# Cambourne to Cambridge: In-Highway Proposals for High Quality Public Transport Scheme

*Produced for Cambridge Past, Present & Future  
by Edward Leigh MA MSc, February 2021*

Figure 7a: Annotated satellite map of proposed interventions on Madingley Rd (continued east on next pages)

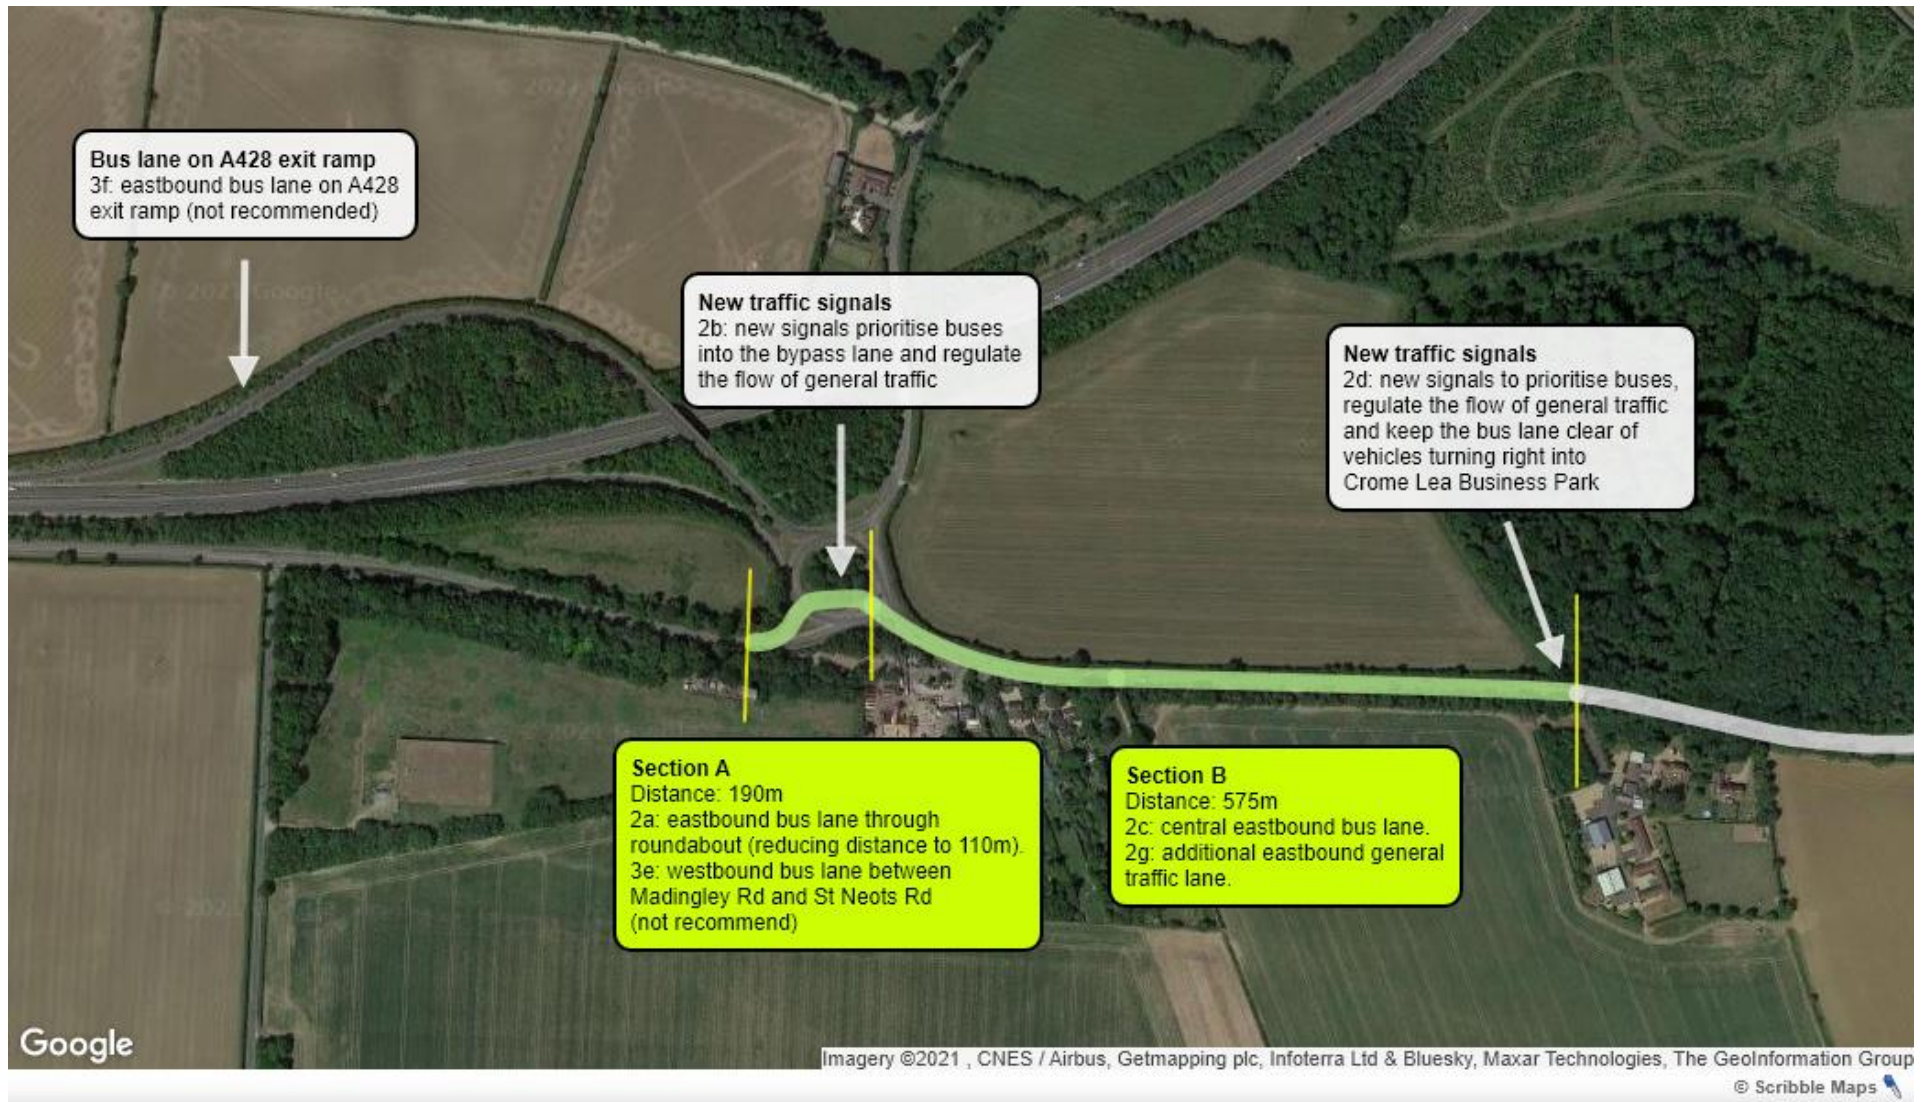
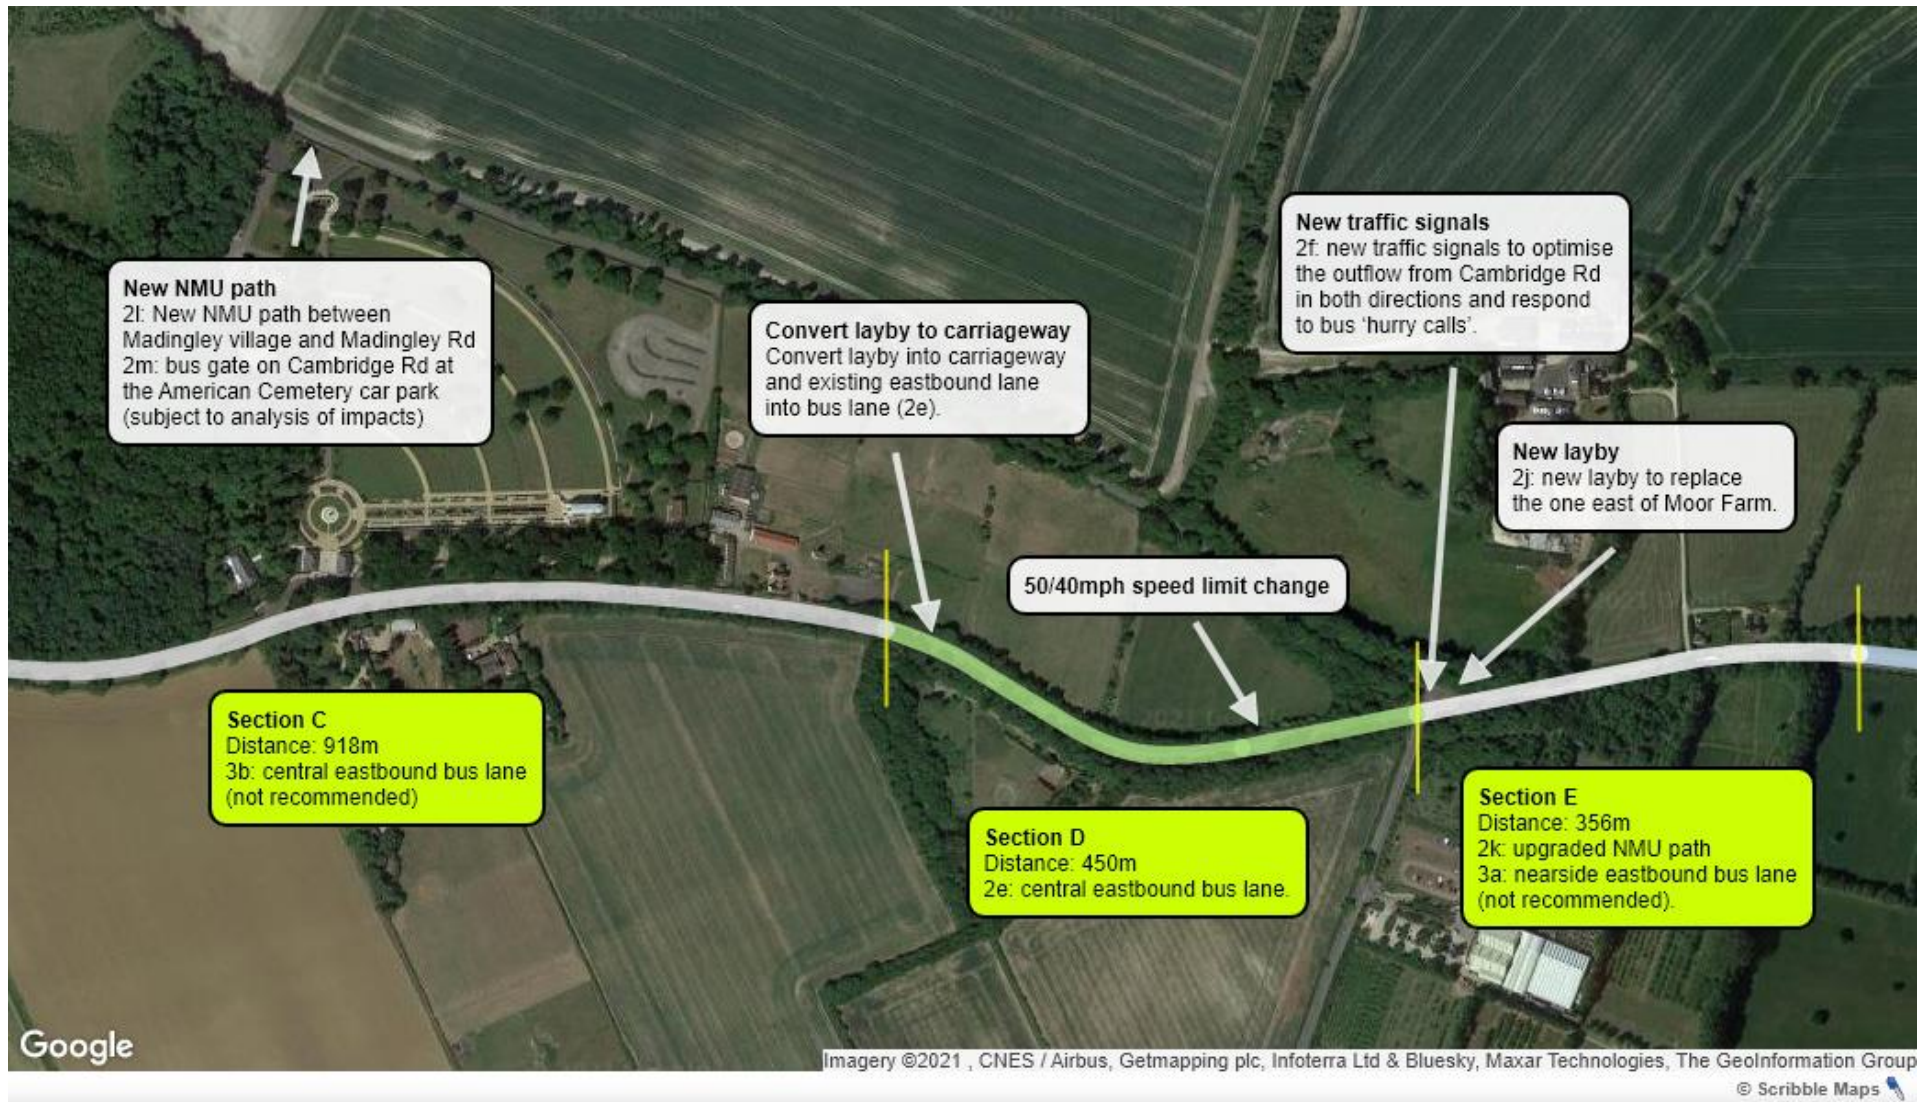
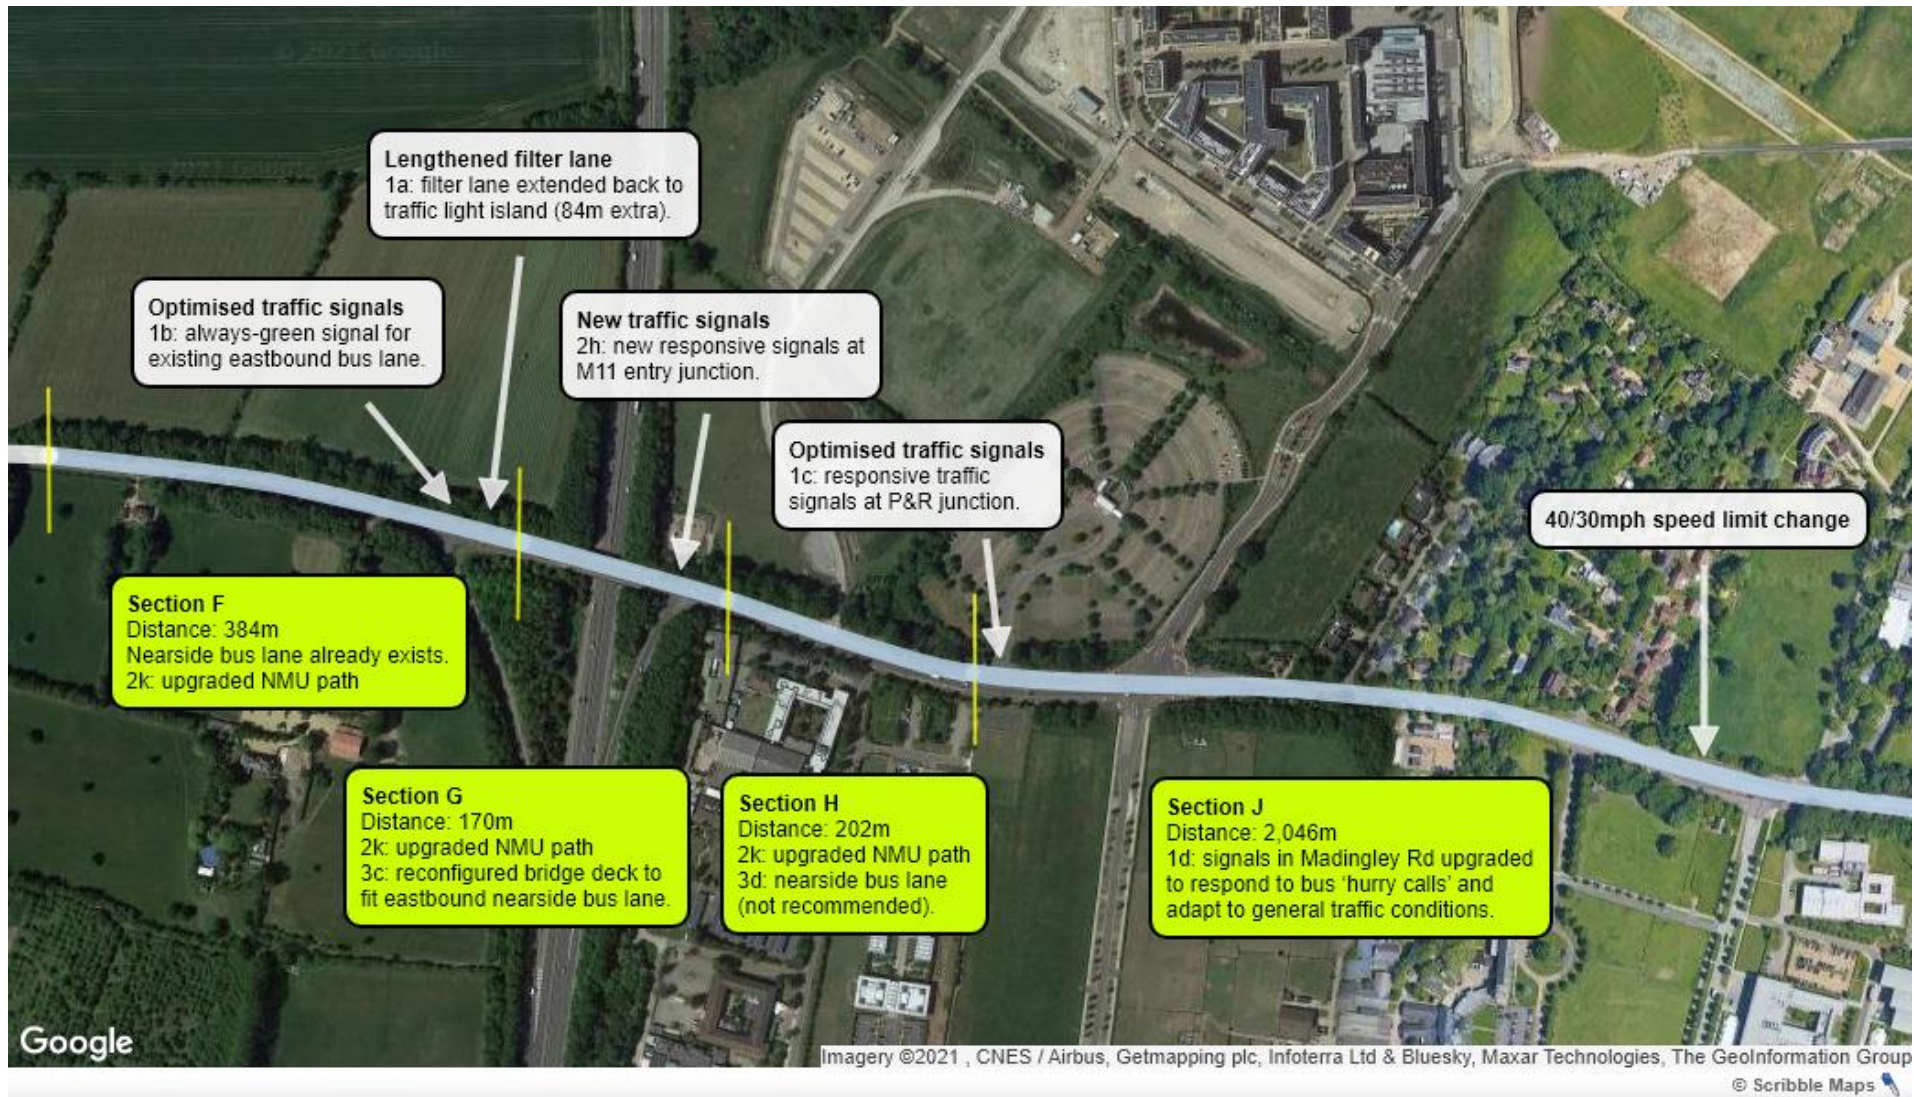
The route is examined inbound from Madingley Mulch roundabout to Queen’s Rd in sections (see Figure 7). The assessed benefits of recommended interventions, and how they are calculated, is set out in Table 1 towards the end of this document; other interventions warranting consideration, but not recommended, are set out in Table 2. See the glossary (above) for details of the reports referenced by abbreviations.

Figure 10: Changes proposed to A1303 at M11 junction as part of Bourn Airfield planning application (S/3440/18/OL)

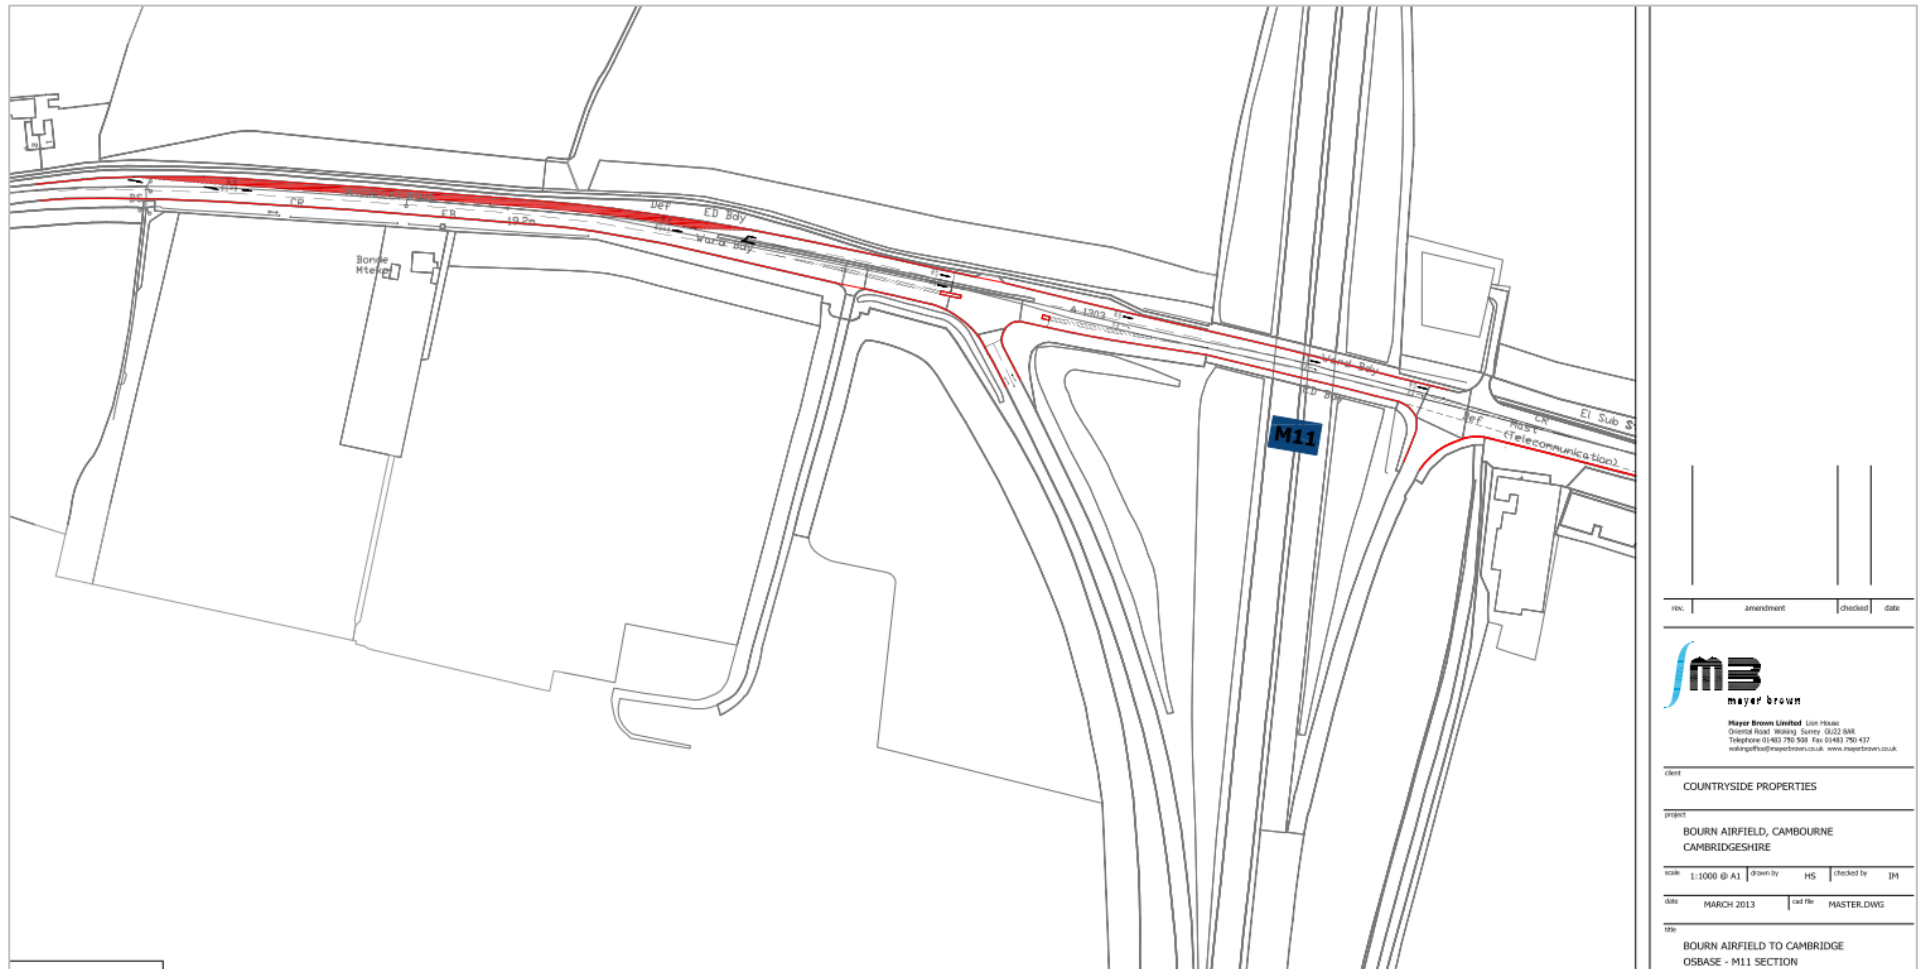
Note that the planning application for Bourn Airfield (S/3440/18/OL) includes a similar proposal to segregate M11-bound traffic from city-bound traffic (see Figure 10). Both options should be modelled with accurate peak-time traffic volumes to determine which benefits buses more.

Figure 12: Highway boundary south of Madingley Mulch roundabout – Section A (from TSM © Crown)

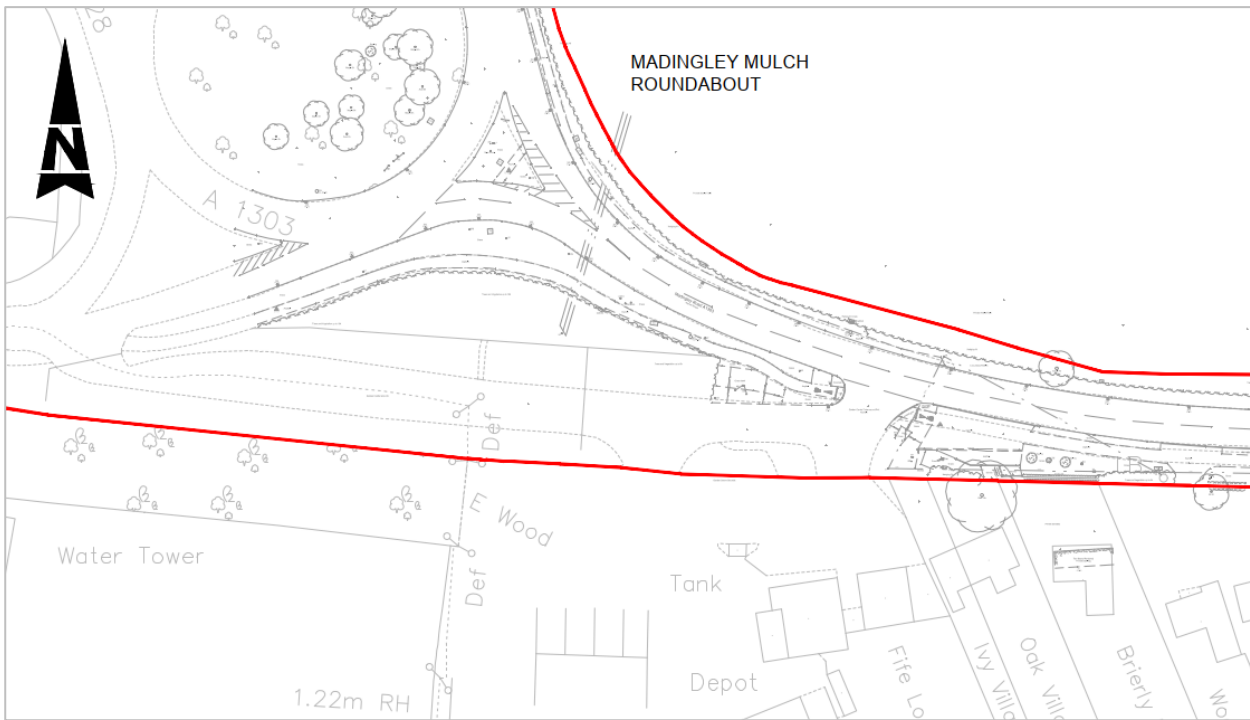
**3e. Outbound bus lane:** A westbound nearside bus lane could be accommodated within highway land to the south of Madingley Mulch roundabout (see Figure 12). This would provide buses with a congestion-free route if and when a queue builds on the approach to the roundabout (see Figure 13). (Reviewed in QW3.1.)

Figure 14: Four-lane configuration of M11 “Rectory Farm” bridge (from RFB page 33 © 2016 Atkins Ltd)

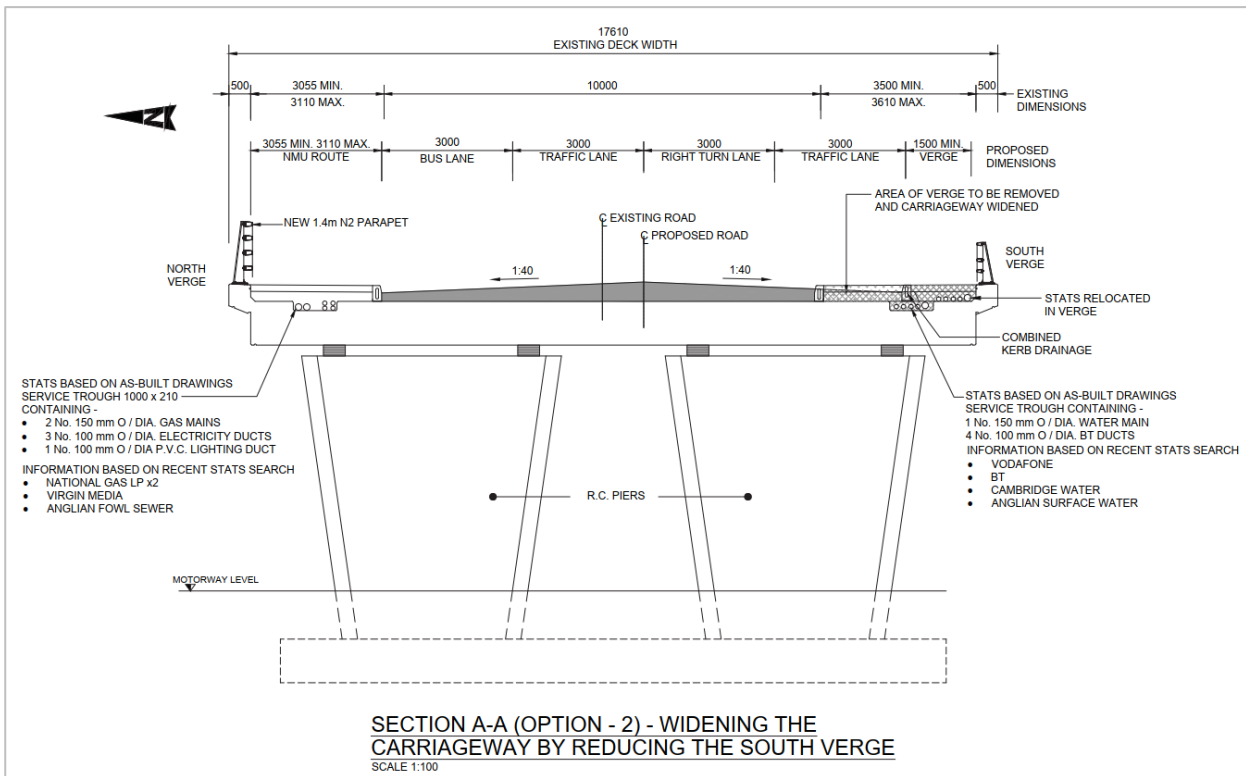
**3c. Bus lane (not recommended):** Although RFB details in Option 2 (see Figure 14) how the bridge can accommodate four 3m-wide traffic lanes in addition to the existing NMU lane, the gain is relatively small once the filter lane is extended beyond behind the end of the existing bus lane (1a).

Figure 16: The Comberton Greenway (green) could be extended (blue) via the Harcamlow Way bridleway to Highfields Caldecote (shown here on the Ordnance Survey map)

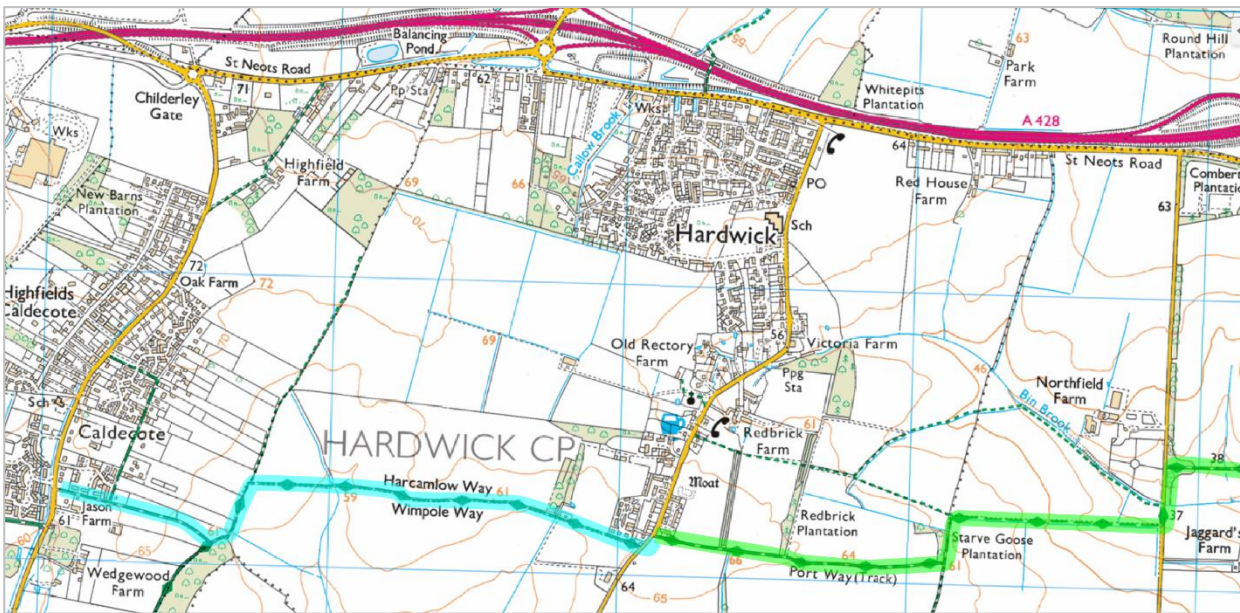
We propose a westward extension of the already-agreed Comberton Greenway. From Hardwick it would go to Highfields Caldecote via an existing bridleway, and then to Cambourne via a new route through the Bourn Airfield site (Figure 16). We also propose an NMU path be built from Madingley, and upgraded east of the Cambridge Rd junction. A bus gate on Cambridge Rd behind the American Cemetery may be needed to stop drivers trying to bypass queues on Madingley Hill. Cambourne is long overdue a bus station.
